DESIGN REVIEW BOARD DECISION

DATE: March 9, 2023
FILE NUMBER: DRV22-00569
PROJECT NAME: Polaris at Totem Lake
APPLICANT: Dane Knudson, with Olson Projects
PROJECT PLANNER: Jennifer Anderer, Associate Planner

12335 120TH AVENUE NE, KIRKLAND, WASHINGTON 98034
DESIGN RESPONSE CONFERENCE - ROUND 2
11.07.2022

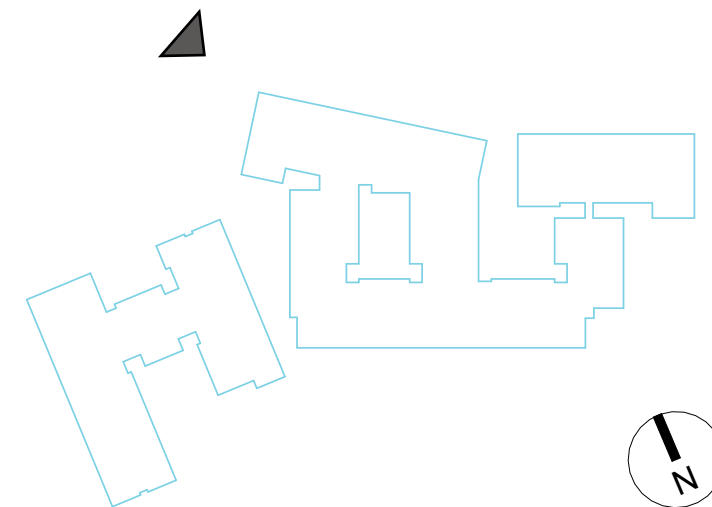
- 1.) Increase overall modulation and articulation particularly along 120th Ave NE

- (A) Material articulation
- (B) Texture variation - changes in fiber cement patterns from smooth to coarse help to add movement in the building facade which can be visible at various directions and times of the day
- (C) Additional modulation at levels 5 and 6 on Tower A - East Wing
- (D) Roof line parapet modulation - See page 7 for more information
- (E) Similar 2/3 Proportional relationship as Tower A - West Wing to create bookend appearance
- (F) Additional fenestration type/style to help further breakdown the scale of the facade and highlight more activated spaces within the building - See page 8 for more information
- (G) Vertical modulation to help break the corner anchor element from the rest of the primary building mass and emphasize verticality along the facade

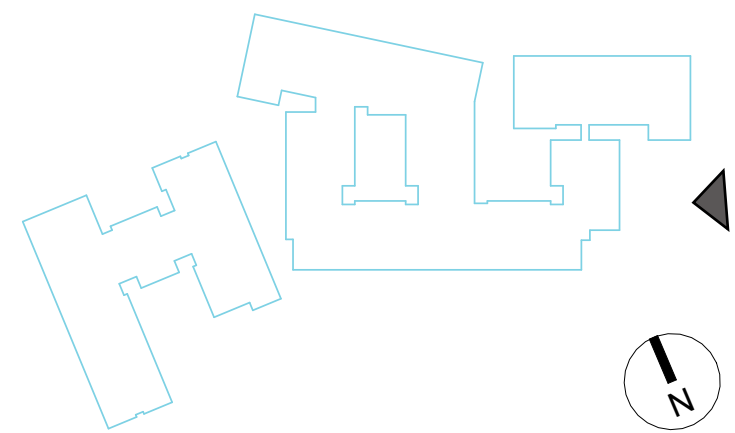
- 1.) Increase overall modulation and articulation particularly along 120th Ave NE

- (A) Material articulation
- (B) Texture variation - changes in fiber cement patterns from smooth to coarse help to add movement in the building facade which can be visible at various directions and times of the day
- (C) Additional modulation at levels 5 and 6 on Tower A - East Wing
- (D) Roof line parapet modulation - See page 7 for more information
- (E) Similar 2/3 Proportional relationship as Tower A - West Wing to create bookend appearance
- (F) Additional fenestration type/style to help further breakdown the scale of the facade and highlight more activated spaces within the building - See page 8 for more information
- (G) Vertical modulation to help break the corner anchor element from the rest of the primary building mass and emphasize verticality along the facade

CORNER ANCHOR

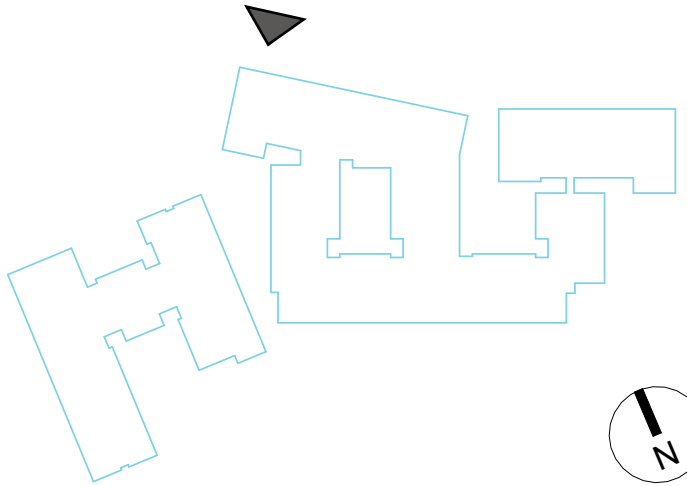
- 4.) Expand the corner tower so it functions as an accent and anchor of the building

We have revised numerous aspects of the corner anchor element from our last DRC meeting on October 3rd. Based on the boards feedback there was just something intangible about this portion of the building that didn't correlate to the rest of project and furthermore lacked definition to further promote an "anchor element". The following points represent the revisions that have taken place:

- (A) We revised the column layout to better align with the perimeter of the corner anchor and help ground this element
- (B) Vertical modulation to help break the corner anchor element from the rest of the primary building mass and emphasize verticality along the facade
- (C) Raised the parapet to help emphasize the priority of this corner anchor element
- (D) Removed the parapet extension to isolate this element and once again promote vertically
- (E) We revised the fenestration on both facades to provide larger openings and therefore create a stronger more visually interesting aspect of the project

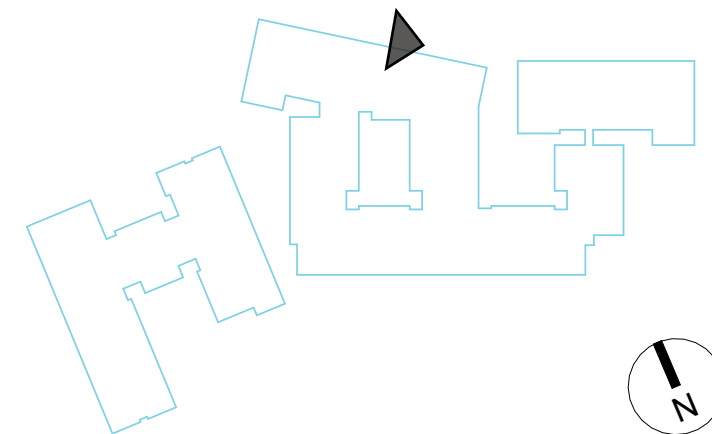
- 1.) Ground floor activation through use of benches, pavers, landscaping.
- 2.) Expand the amount of frontage along 120th Ave NE that engages the public.
- 3.) Explore artwork opportunities within enhanced landscaping spaces particularly in and around the parking garage.

- (A) By providing more seating nodes along the frontage we have created more opportunities of reprieve, interaction as well as reflection for patrons and the public alike
- (B) The intent is to provide a decorative paving pattern either through the use of linear concrete pavers in multiple gray tones or through saw cut concrete slab on grade
- (C) By reducing the square footage of certain raised planters we have revised the proposed open space layout to provide more area for pedestrian circulation and gathering
- (D) We have enhanced the pedestrian experience along 120th Ave. NE by taking the board's advice and incorporating a "butterfly garden" through the use of specific landscaping techniques
- (E) We have also provided decorative metal panels as a backdrop to the landscaping which doubles as screening for the proposed surface parking lot in this region of the project

PEDESTRIAN-FRIENDLY BUILDING FRONTS

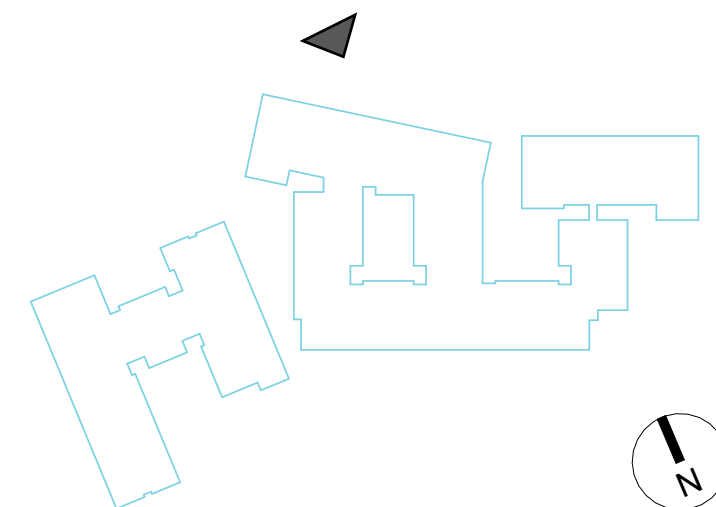
- 1.) Ground floor activation through use of benches, pavers, landscaping.
- 2.) Expand the amount of frontage along 124th Ave NE that engages the public.
- 3.) Explore artwork opportunities within enhanced landscaping spaces particularly in and around the parking garage.

- (A) By providing more seating nodes along the frontage we have created more opportunities of reprieve, interaction as well as reflection for patrons and the public alike
- (B) The intent is to provide a decorative paving pattern either through the use of linear concrete pavers in multiple gray tones or through saw cut concrete slab on grade
- (C) By reducing the square footage of certain raised planters we have revised the proposed open space layout to provide more area for pedestrian circulation and gathering
- (D) We have enhanced the pedestrian experience along 120th Ave. NE by taking the board's advice and incorporating a "butterfly garden" through the use of specific landscaping techniques
- (E) We have also provided decorative metal panels as a backdrop to the landscaping which doubles as screening for the proposed surface parking lot in this region of the project

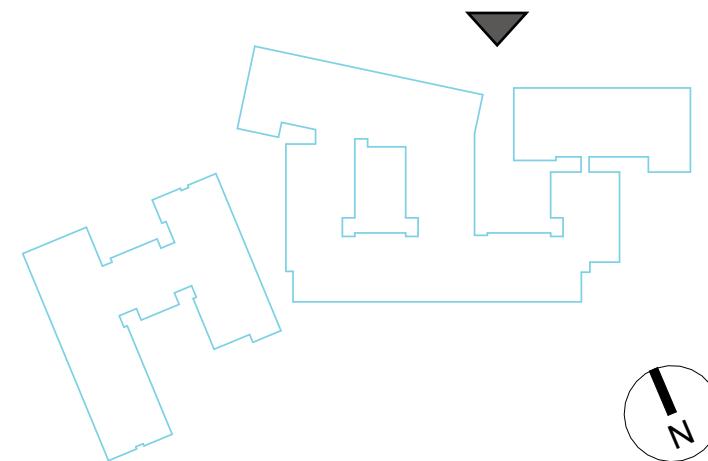
- 1.) Consider stair access to the plaza
- 2.) Can the plaza space spill over into the ramp area for a more blended transition from the sidewalk into the plaza space?
- 3.) Look into use of pavers, stamped concrete, benches
- 4.) Provide a more detailed landscape plan (including species) to address privacy, enhancing the public spaces (plaza etc.), ground floor pedestrian engagement, and seasonal plantings
- 5.) Opportunities to explore with the wide landscape areas

(A) We have revised the pedestrian circulation/access scheme by providing stairways at both the primary entrance into the plaza as well as the public entrance into the parking garage.

(B) We have revised the westerly "ramp" entrance down into the public plaza by increasing the overall width. By reducing the planter widths, increasing the circulation width and providing seating areas along the low planter wall this area allows gathering space to spill over from the plaza as suggested by the board.

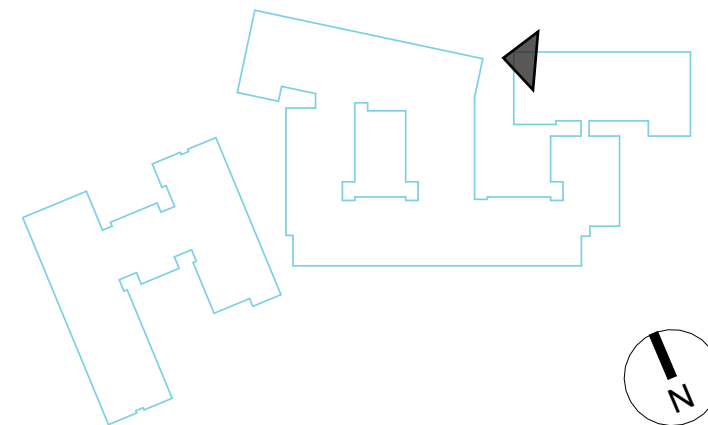
- 1.) Consider stair access to the plaza
- 2.) Can the plaza space spill over into the ramp area for a more blended transition from the sidewalk into the plaza space?
- 3.) Look into use of pavers, stamped concrete, benches
- 4.) Provide a more detailed landscape plan (including species) to address privacy, enhancing the public spaces (plaza etc.), ground floor pedestrian engagement, and seasonal plantings
- 5.) Opportunities to explore with the wide landscape areas

(A) We have revised the pedestrian circulation/access scheme by providing stairways at both the primary entrance into the plaza as well as the public entrance into the parking garage.

(B) We have revised the westerly "ramp" entrance down into the public plaza by increasing the overall width. By reducing the planter widths, increasing the circulation width and providing seating areas along the low planter wall this area allows gathering space to spill over from the plaza as suggested by the board.

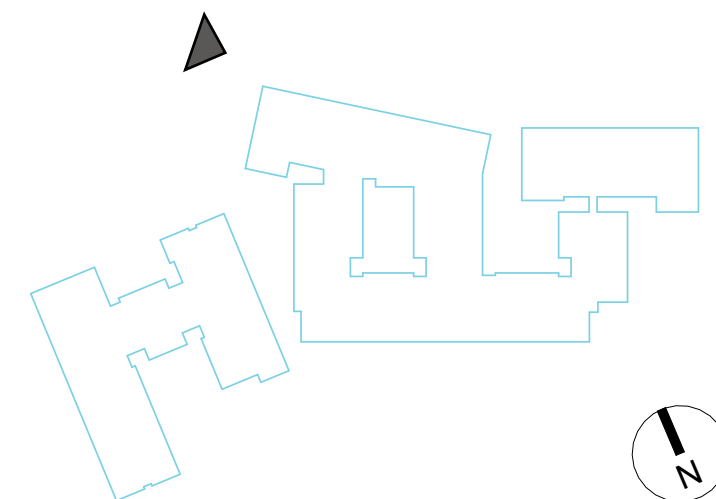
- 1.) Consider stair access to the plaza
- 2.) Can the plaza space spill over into the ramp area for a more blended transition from the sidewalk into the plaza space?
- 3.) Look into use of pavers, stamped concrete, benches
- 4.) Provide a more detailed landscape plan (including species) to address privacy, enhancing the public spaces (plaza etc.), ground floor pedestrian engagement, and seasonal plantings
- 5.) Opportunities to explore with the wide landscape areas

(A) We have revised the pedestrian circulation/access scheme by providing stairways at both the primary entrance into the plaza as well as the public entrance into the parking garage.

(B) We have revised the westerly "ramp" entrance down into the public plaza by increasing the overall width. By reducing the planter widths, increasing the circulation width and providing seating areas along the low planter wall this area allows gathering space to spill over from the plaza as suggested by the board.
